Volvo Chassis - FSB 284 - 069, Exhaust Particulate Sensor, Repair (2017 Vehicles)

FSB 284-069, Exhaust Particulate Sensor, Repair

(November 2021)

Repair 1

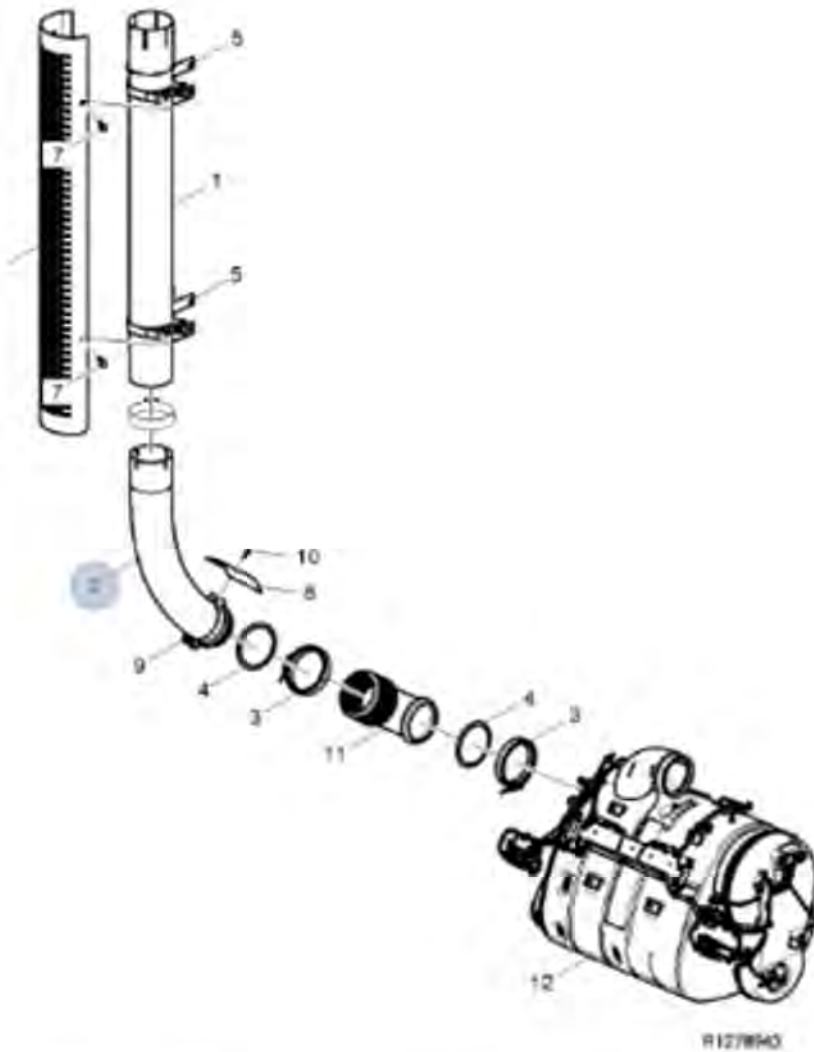
Model	Cab Type	Exhaust Configuration	Pipe 1 (Stack with welded flex)	Pipe 2 (SCR Elbow)	Clamp
VNL	Day Cab	Single Outlet Right Side Outboard	23985907	22181981	25172497

Repair 2

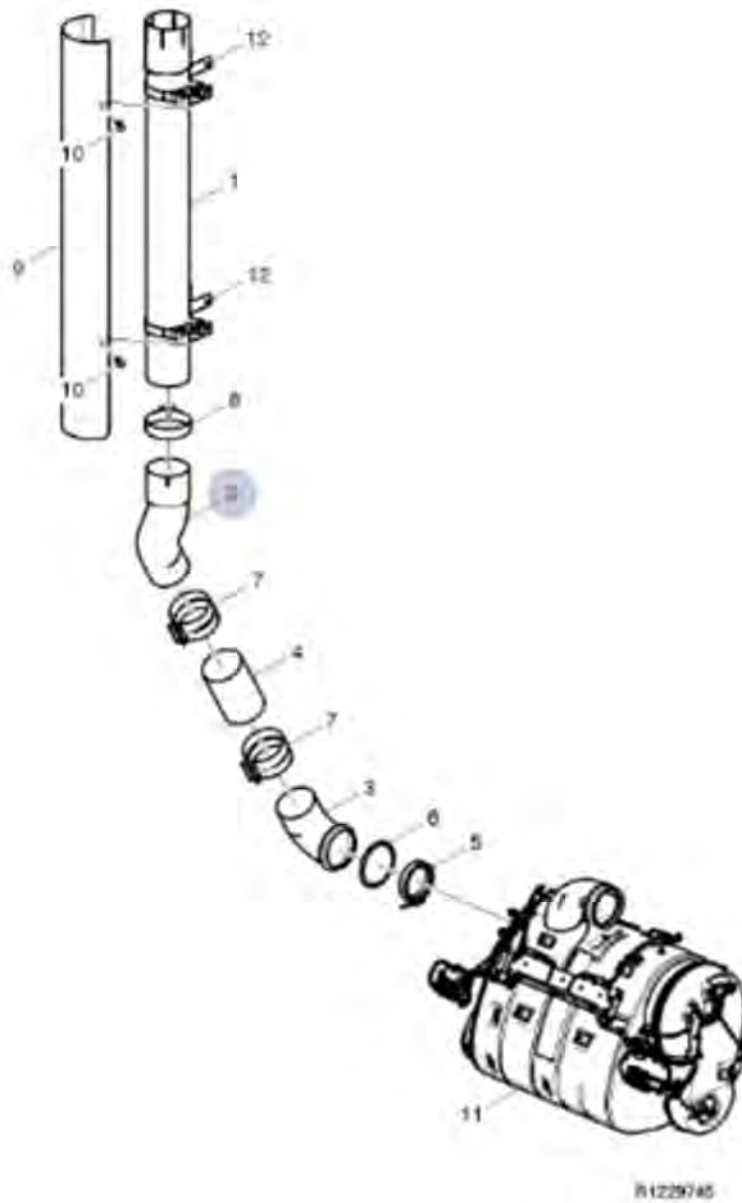
Model	Cab Type	Exhaust Configuration	Pipe 1
VHD – Axle Forward	Day Cab	Single Outlet Right Side Inboard	23155762

Repair 3

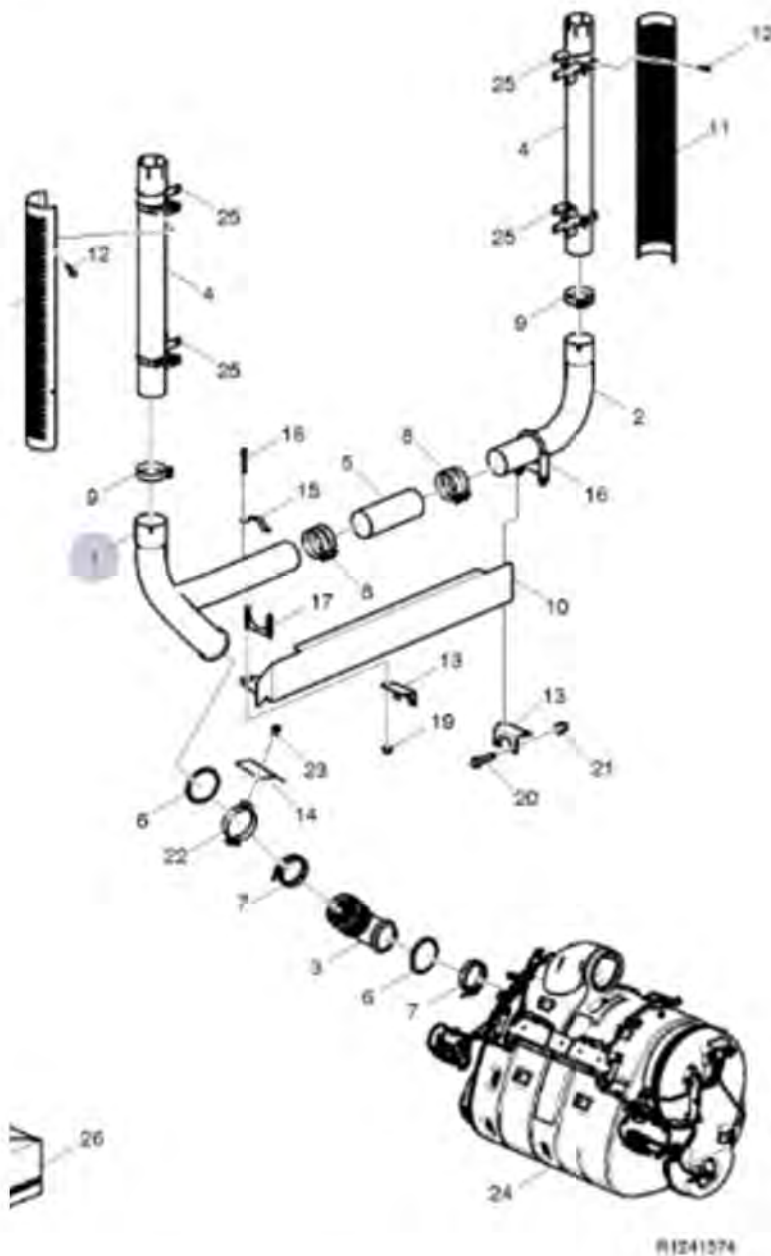
Model	Cab Type	Exhaust Configuration	Pipe 1
VNM/VHD	Day Cab	Single Outlet Right Side Inboard	23630048

Repair 4

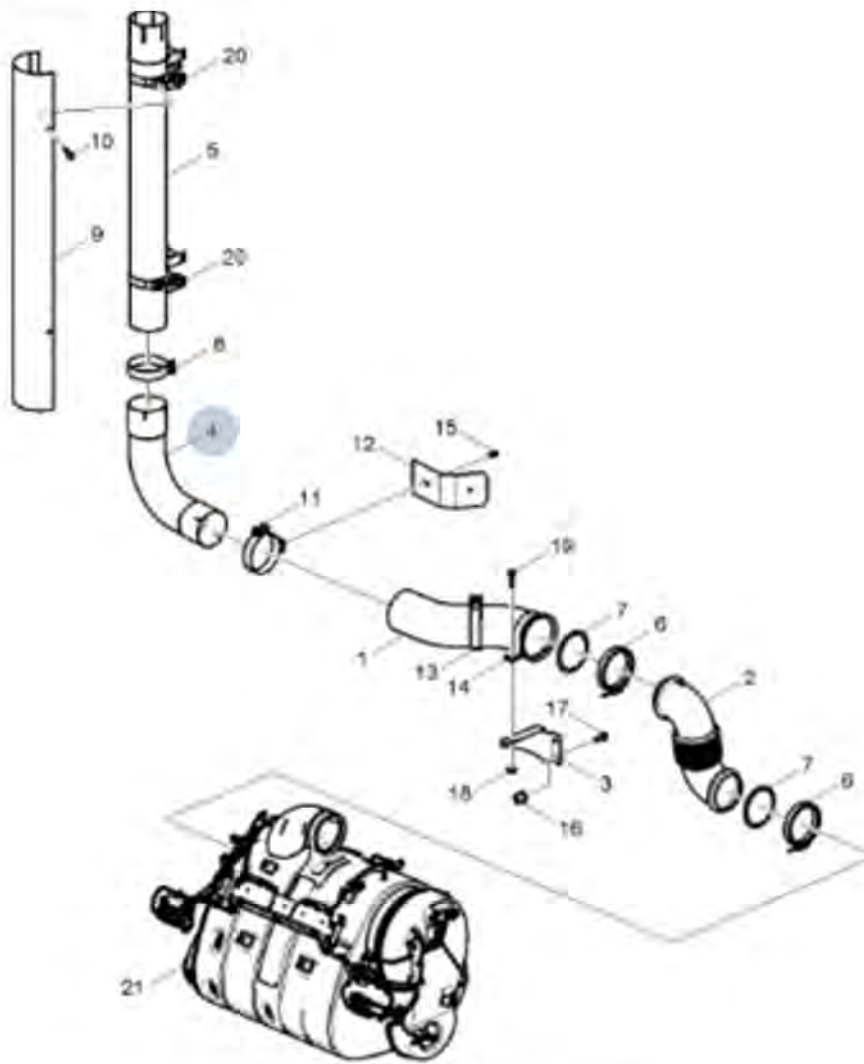
Model	Cab Type	Exhaust Configuration	Pipe 1
VHD Axle Bwd	Day Cab	Dual Outlet	23155774
VHD Axle Fd	Day Cab	Dual Outlet	23155785

Repair 5

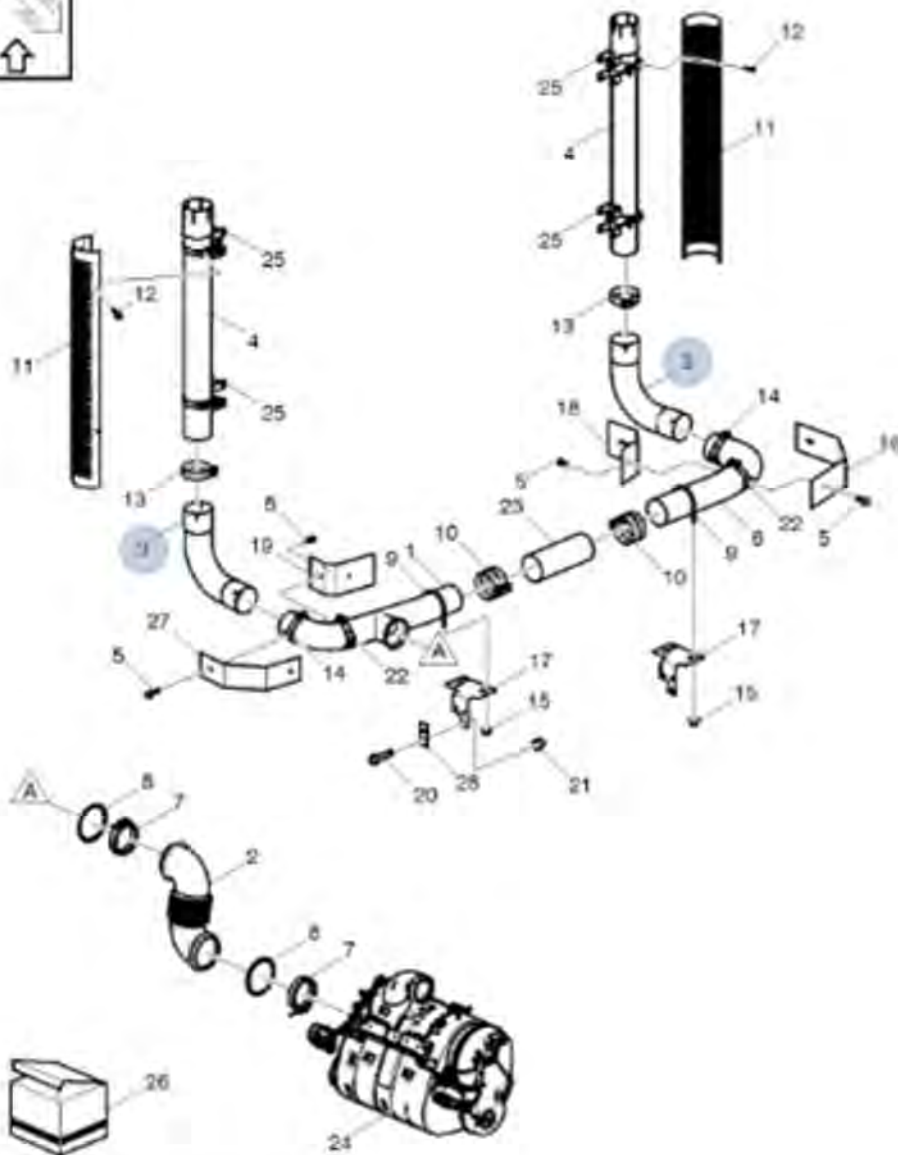
Model	Cab Type	Exhaust Configuration	Pipe 1
VNM VHD VNL	Sleeper Cabs	Single Outlet Right Side Outboard	(Not Bright) 23154798 (Bright) 23154799

Repair 6

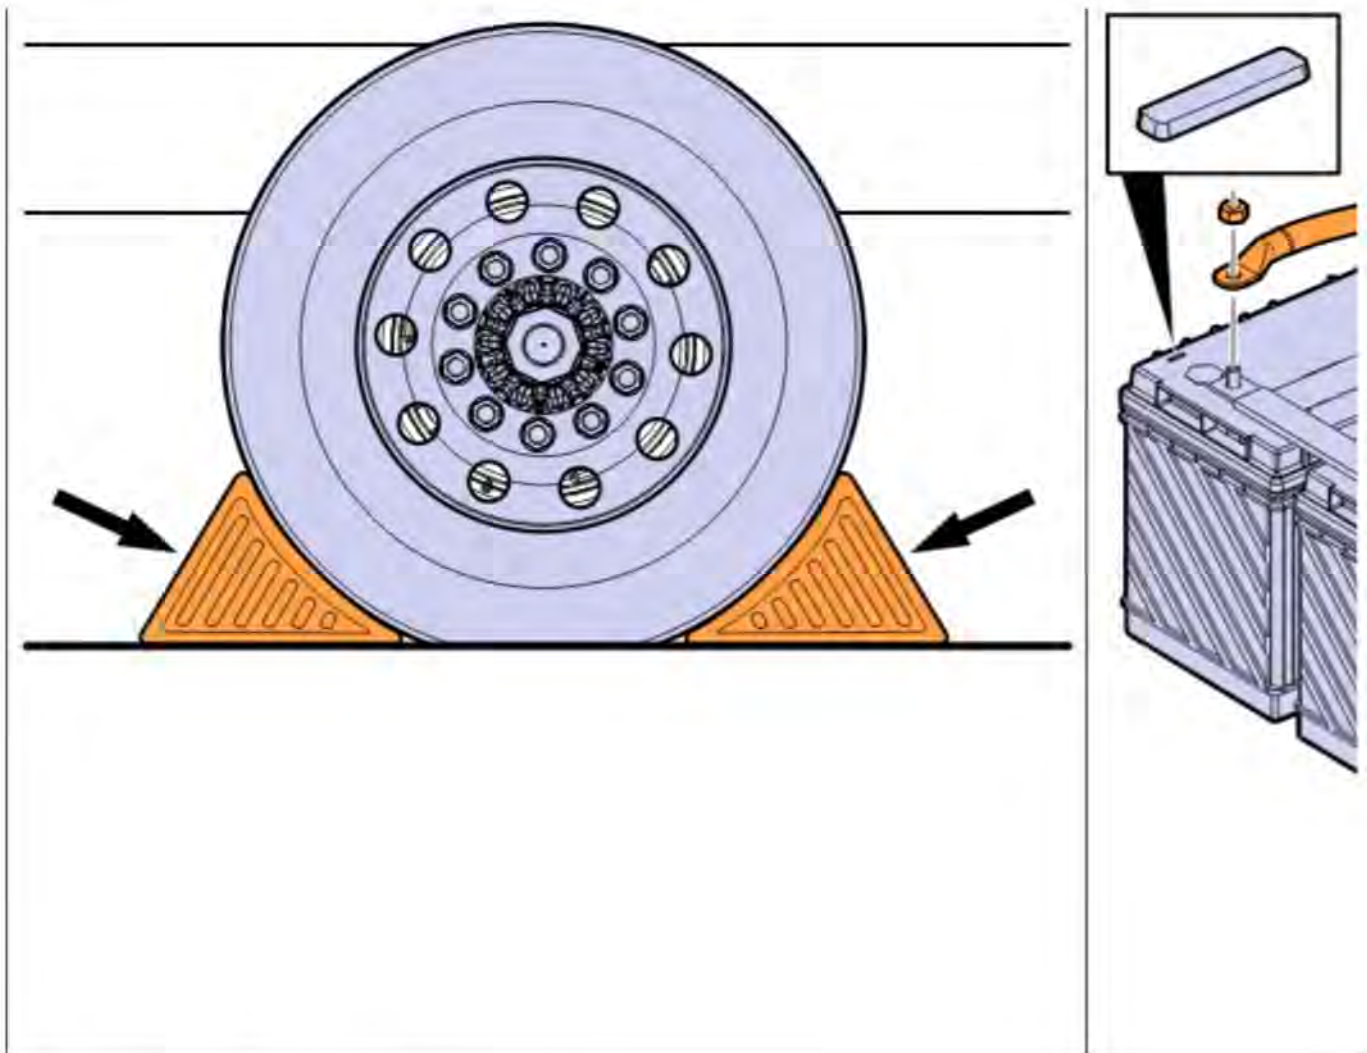
Model	Cab Type	Exhaust Configuration	Pipe 1	Note
VNM VHD VNL	Sleeper Cabs	Dual Outlet Right Side Outboard	(Not Bright) 23154798 (Bright) 23154799	Requires 2 elbows per chassis
